• **CHARGING SYSTEM—HEADLAMPS, INSTRUMENT CLUSTER, RADIO OR INTERIOR LIGHTS FLICKER WHEN COLD—VEHICLES EQUIPPED WITH 2.5L ENGINE ONLY** • **ELECTRICAL—HEADLAMPS, INSTRUMENT CLUSTER, RADIO OR INTERIOR LIGHTS FLICKER WHEN COLD—VEHICLES EQUIPPED WITH 2.5L ENGINE ONLY**	**Article No. 00-25-6**

MERCURY: 1999-2000 COUGAR

Figure 1 - Article 00-25-6

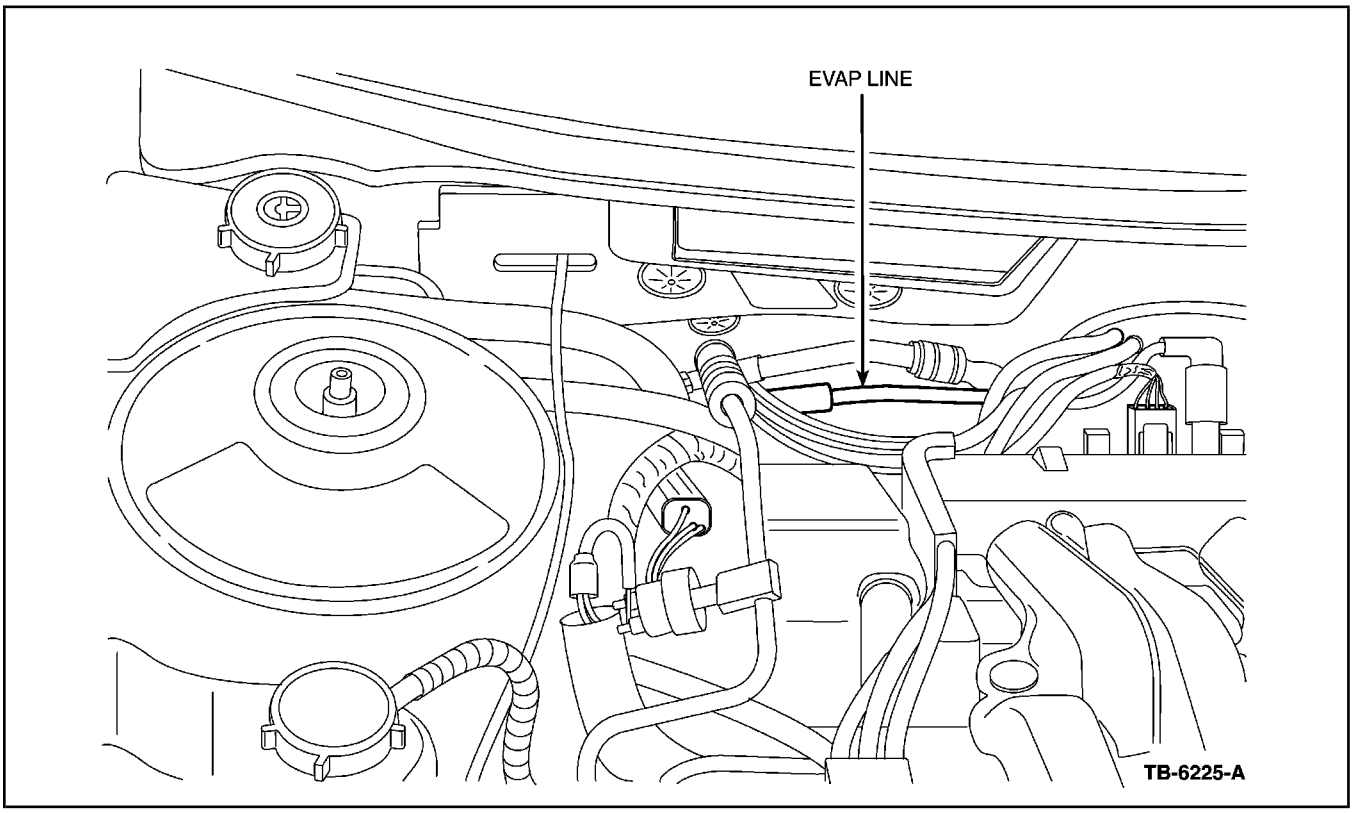
1. Verify condition.
2. Disconnect battery ground.
3. Disconnect EVAP emissions line at back of engine (Figure 1).
4. Remove battery voltage sensing/alternator fuse (circuit 30-BA8) from the engine compartment power distribution box (fuse 7 for vehicles built before 5/24/1999 and fuse 2 for vehicles built after 5/24/1999).

Figure 2 - Article 00-25-6

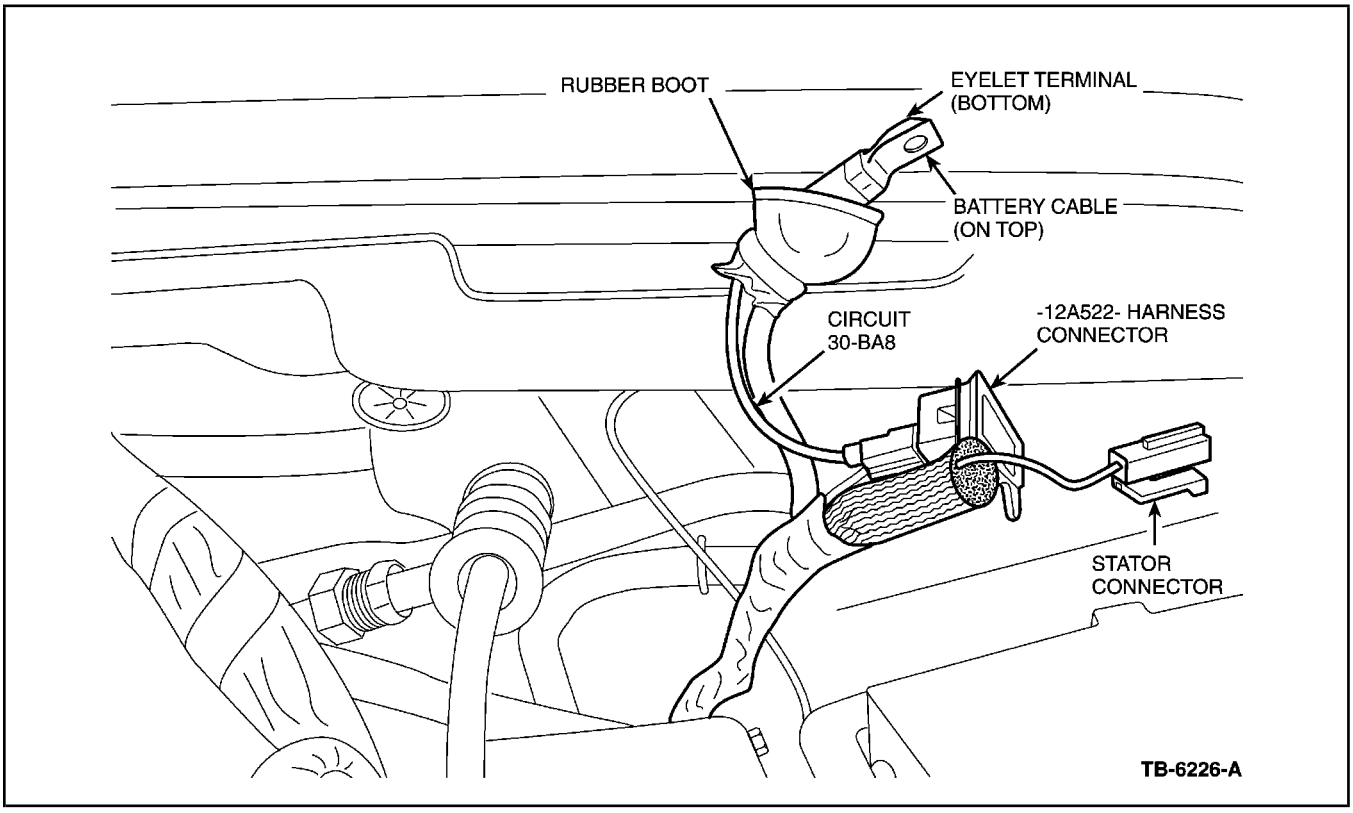
13. If L-shaped plastic shield is on the battery cable, untape and remove.
14. Slide eyelet terminal through rubber boot on battery cable such that the new terminal is on the bottom (Figure 2).

21. Connect battery cable and new terminal to B+ stud (new terminal on stud first) and torque nut to 8.0 ±1.2 N•m (70 ±10 lb-in).
22. Lower vehicle.
23. Connect battery ground cable.
